AGENDA

ST. TAMMANY PARISH PLANNING COMMISSION MEETING 6:00 PM - TUESDAY SEPTEMBER 8, 2020 ST. TAMMANY PARISH GOVERNMENT COMPLEX PARISH COUNCIL CHAMBERS 21490 KOOP DRIVE, MANDEVILLE, LOUISIANA

2020-1970-FP

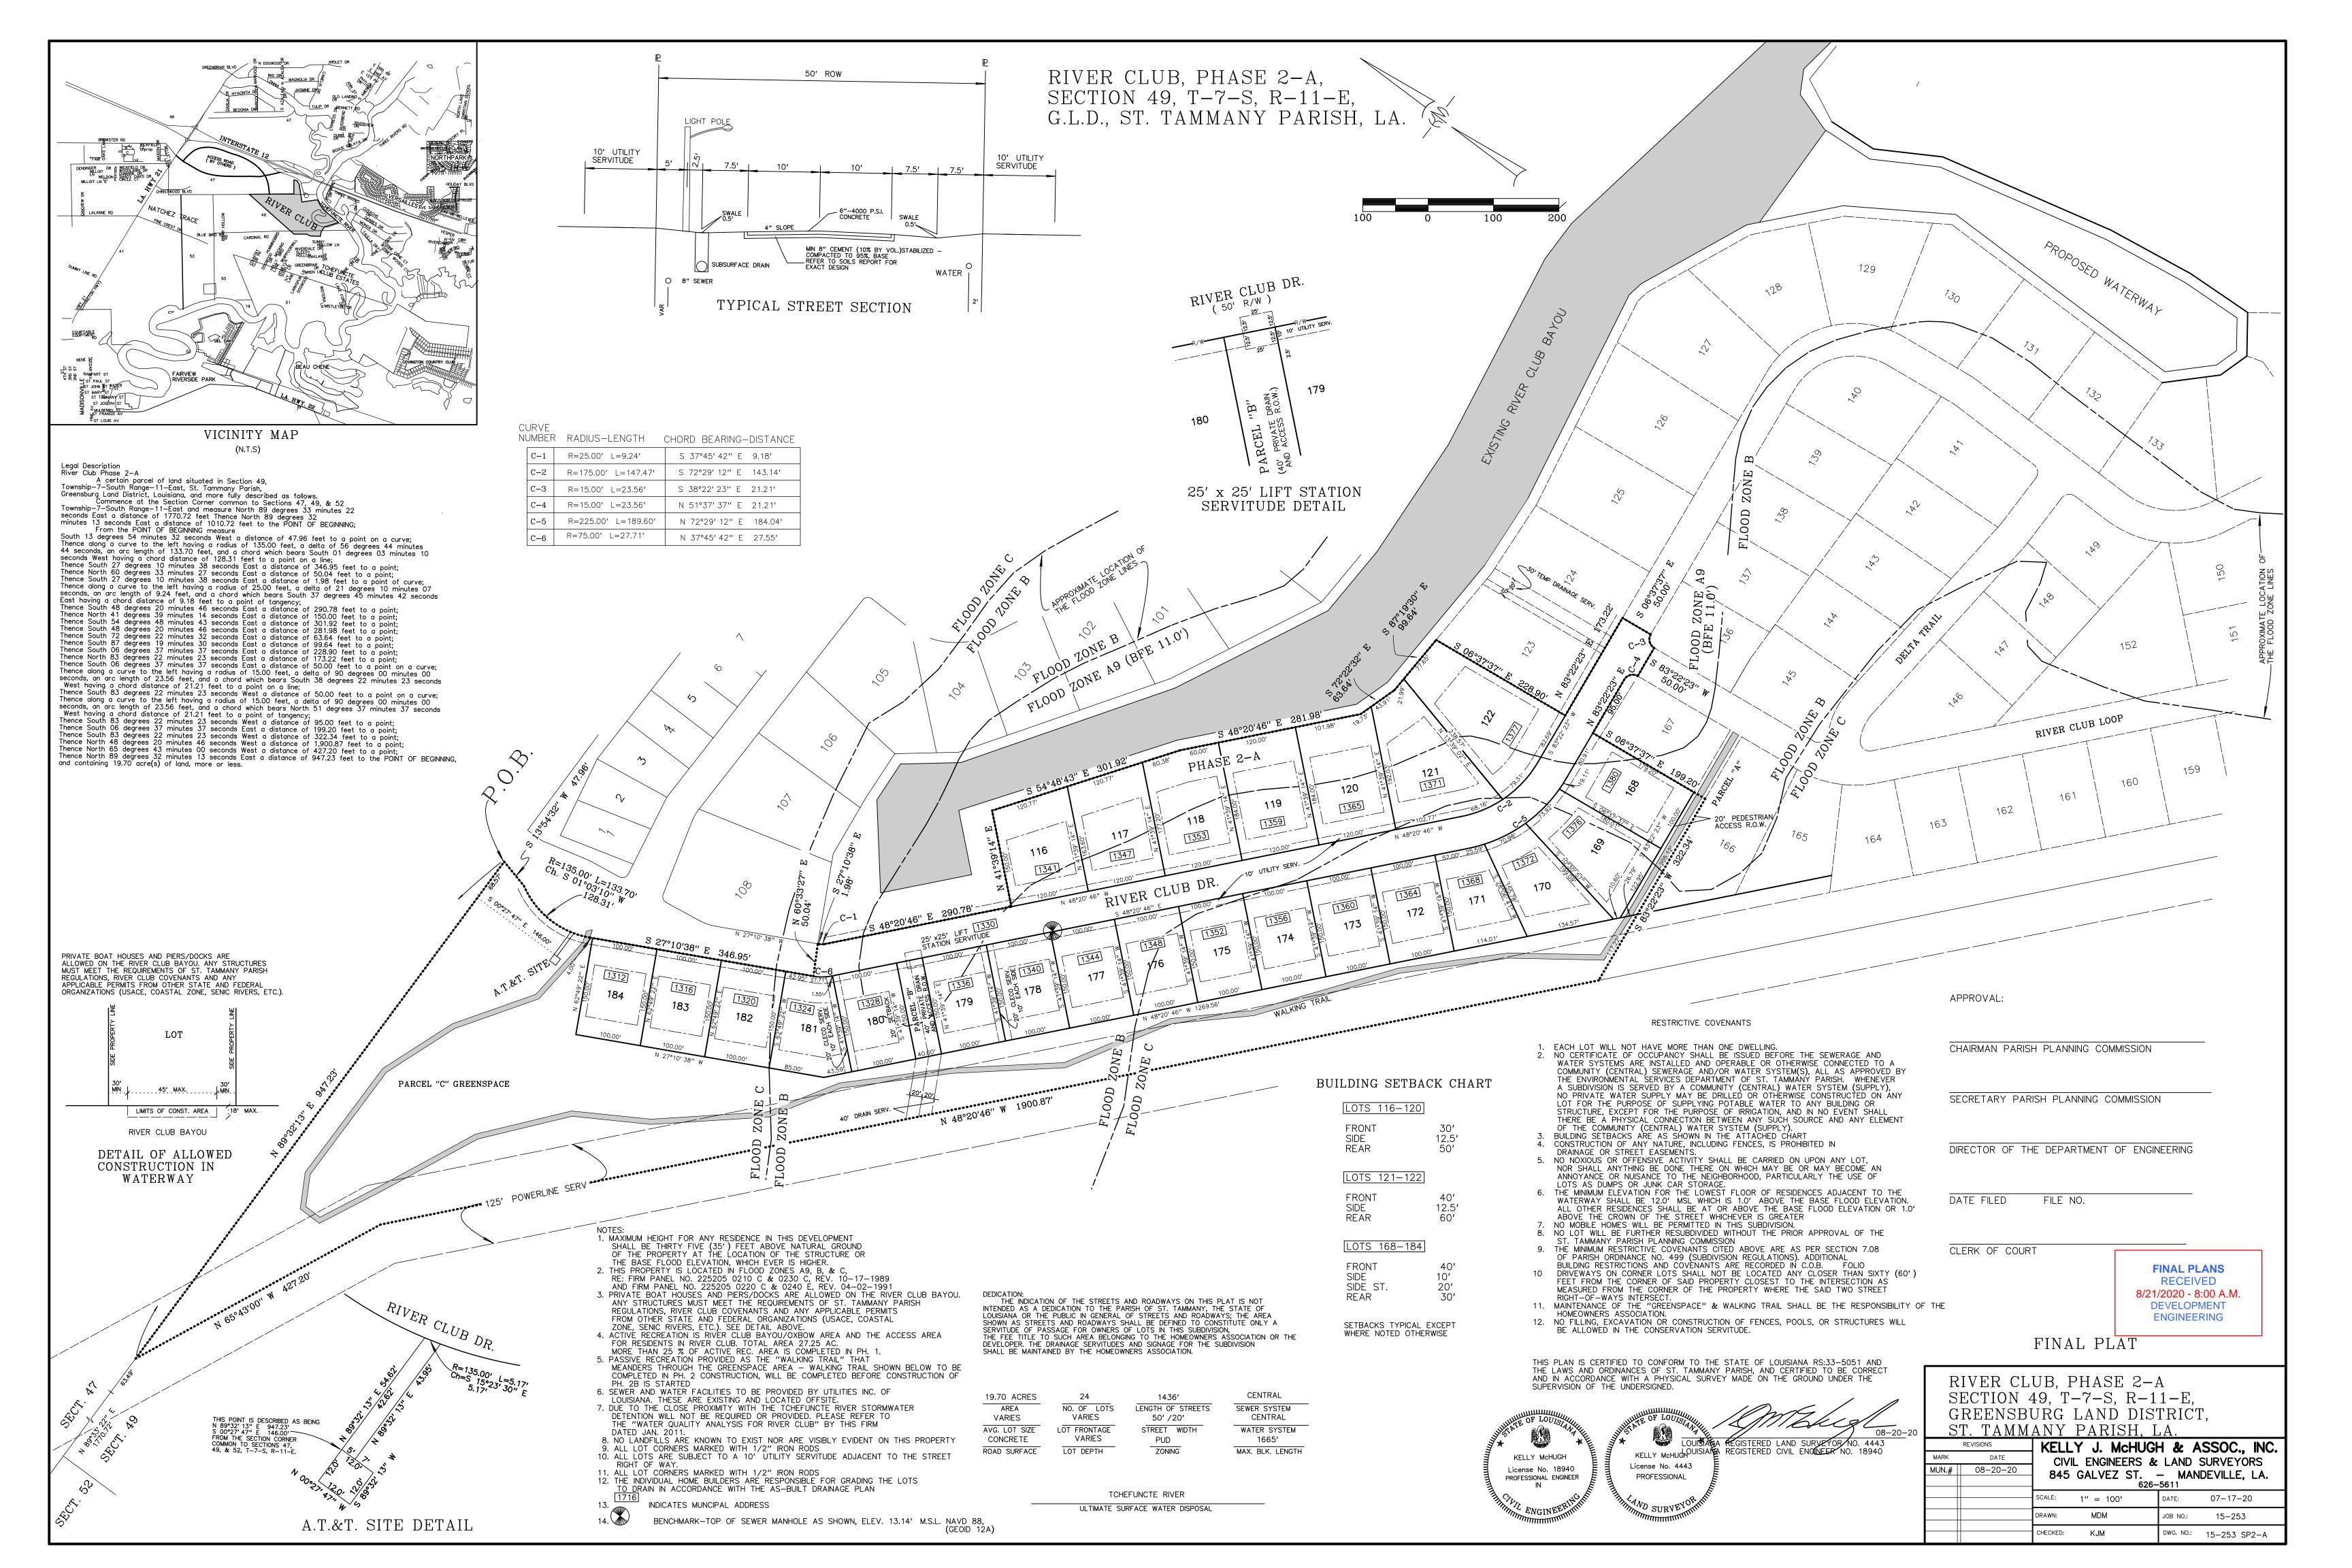
- 1. Rip-rap or a crushed stone splash pad needs to be installed at the end of the 30' temporary ditch servitude between Lots #123 & #124 in accordance with the provided drainage plan.
- 2. All drainage ditches, roadside ditches and swales need to be properly vegetated for this phase of River Club.

- 3. Provide clear water tests for the new water lines installed in association with this phase of River Club.
- 4. Provide a letter of acceptance and responsibility for the perpetual maintenance and operation of the water and sewer systems from the utility provider.

2020-2013-FP

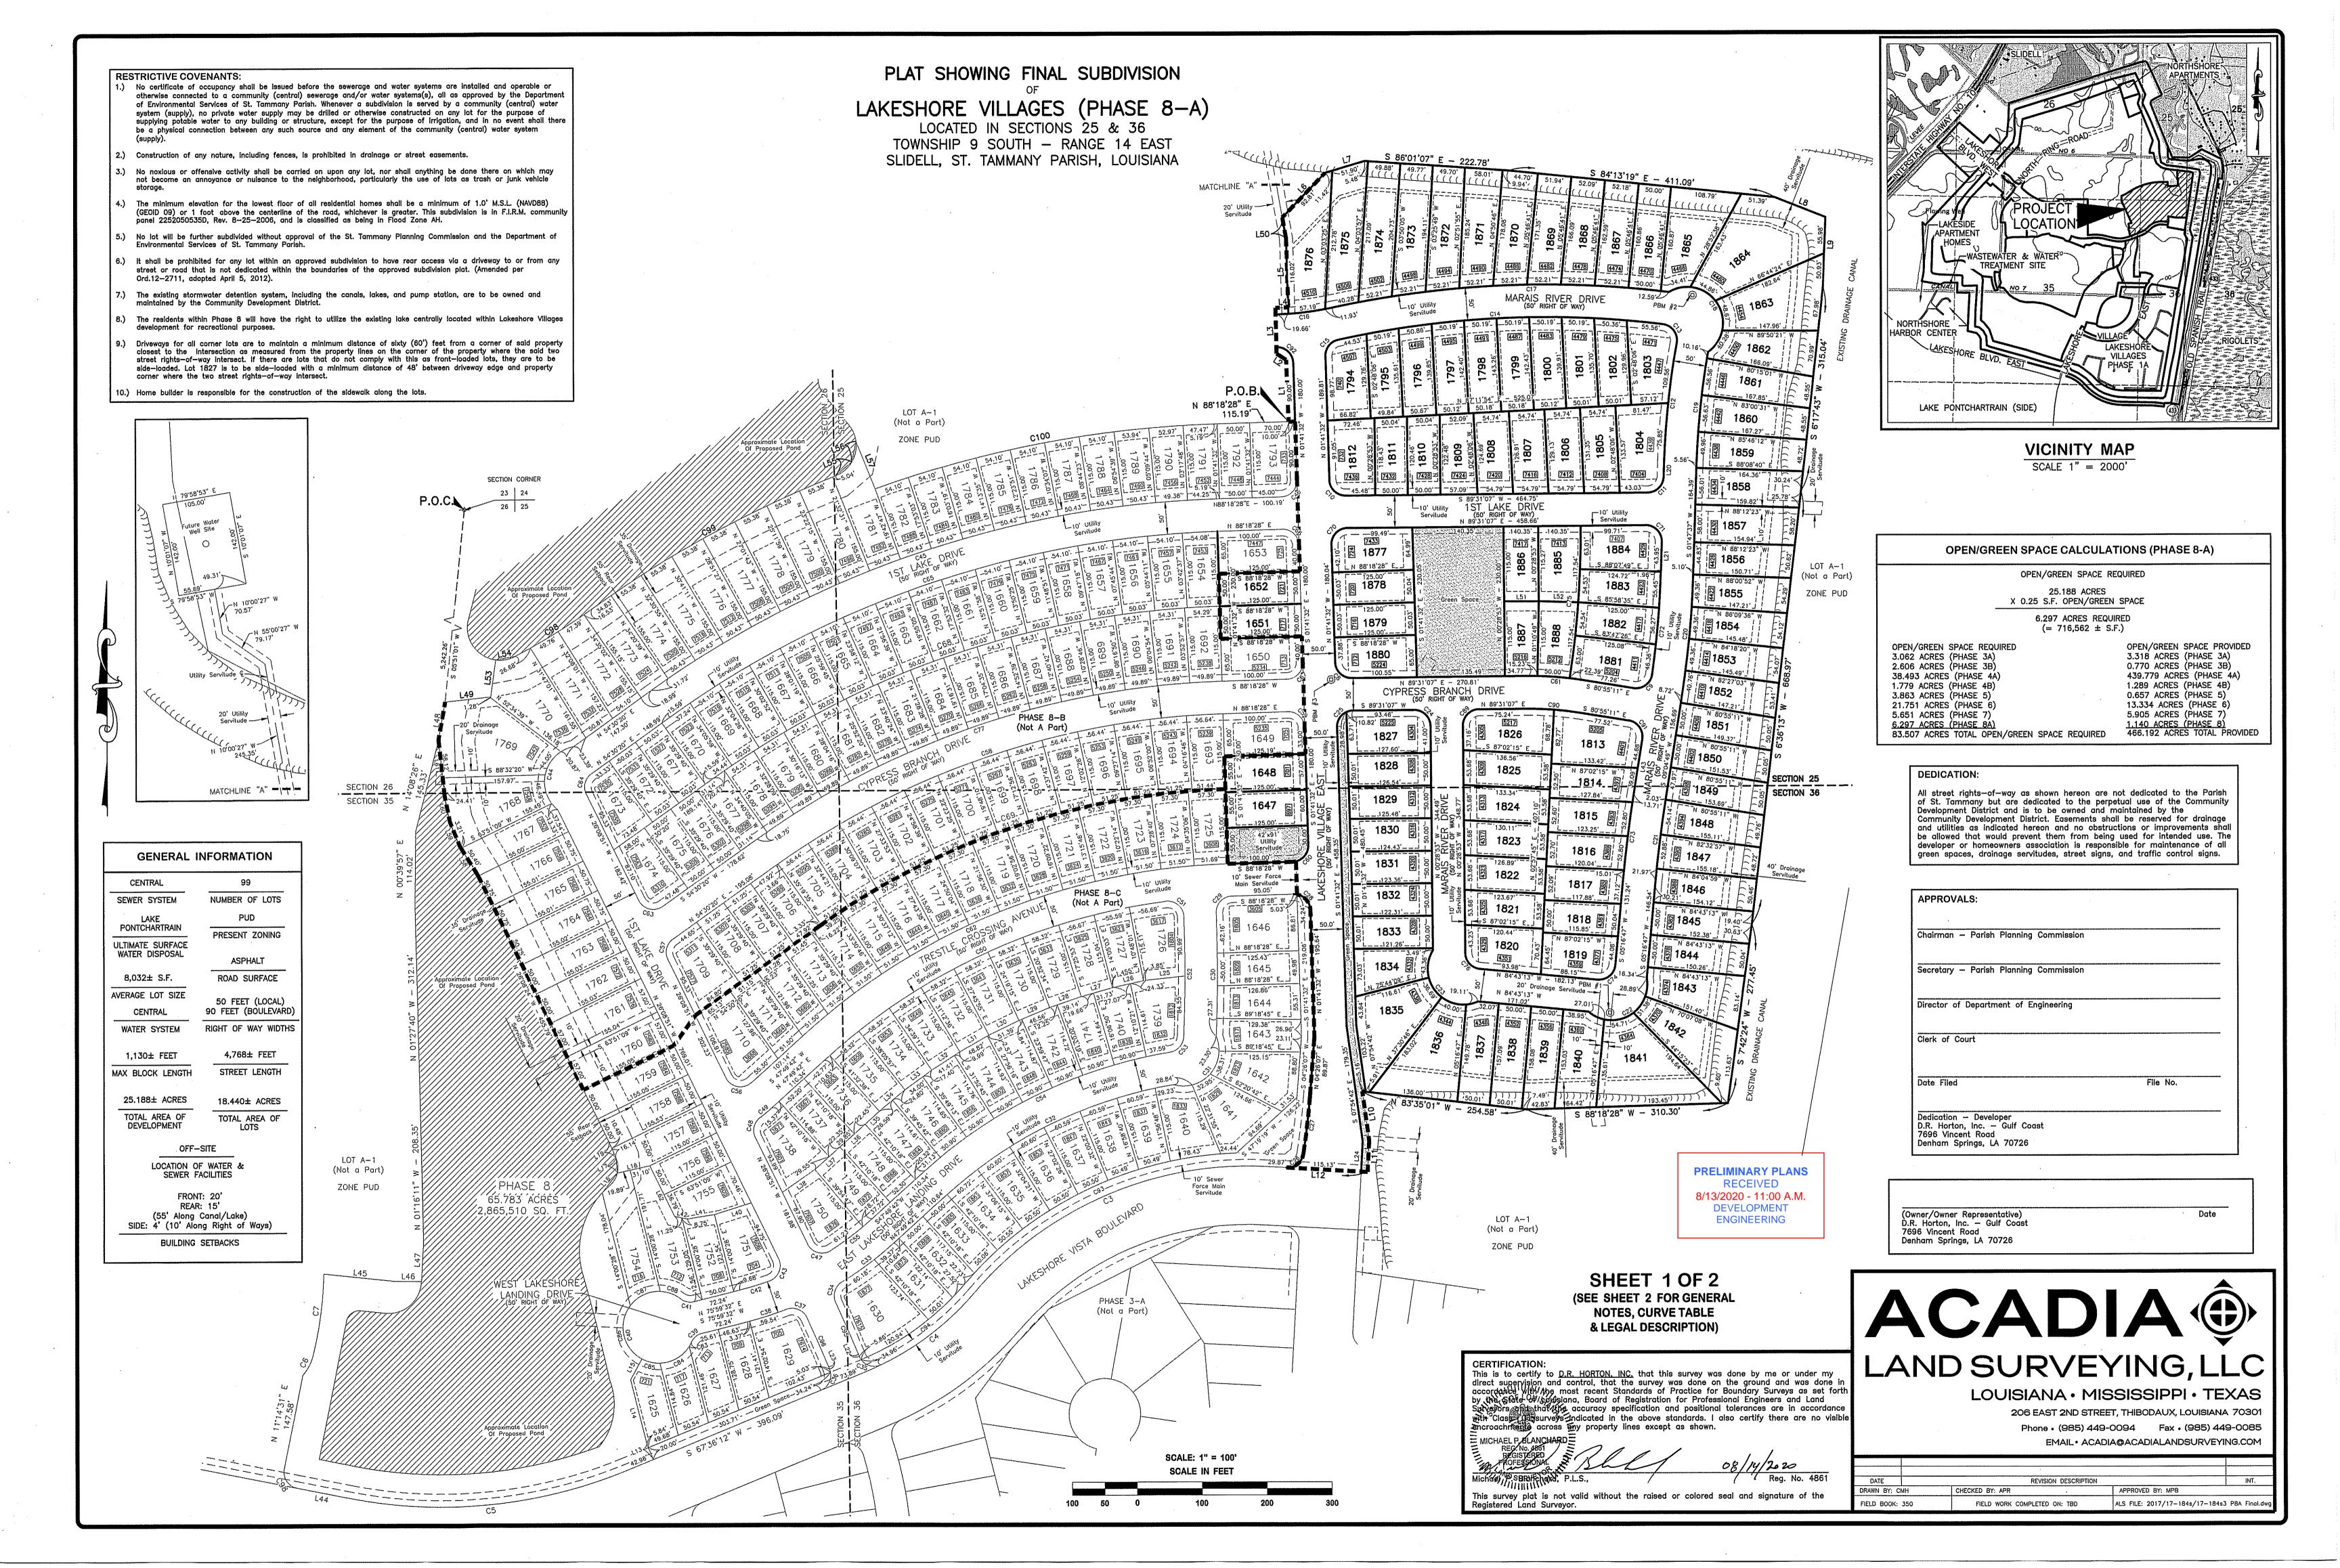
- 1. The streets throughout this phase of Lakeshore Villages need to be cleaned so a meaningful inspection can be made.
- 2. Repair all cracks and re-establish any washouts associated with the sidewalk in this phase of Lakeshore Villages.
- 3. Straighten all crooked signage as needed throughout this phase of Lakeshore Villages.
- 4. Install blue reflectors in the vicinity of the hydrants where missing.
- 5. Overhead power lines remaining along Lakeshore Villages East are in conflict with the proposed home locations and are not located within a dedicated servitude. Provide clarification regarding the plans for these power lines.
- 6. Need asphalt test results for Marais River Drive, 1st Lake Drive and Cypress Branch Drive.

- 7. Provide as-built elevations at all property corners and on all greenspace parcels.
- 8. Show drainage arrows on all lots and greenspace parcels.
- 9. Revise the drainage arrows on the as-built paving & drainage plan(s) to show split lot drainage for lots with a drainage canal located along the rear of the lot.

- 10. As-built information for the sewer lift station and sewer force main that services this phase of Lakeshore Villages needs to be provided.
- 11. Provide a water and sewer capacity letter from Oak Harbor East Utility for this phase of Lakeshore Villages.
- 12. Provide a Letter of Acceptance for the water and sewer infrastructure associated with this phase of Lakeshore Villages.
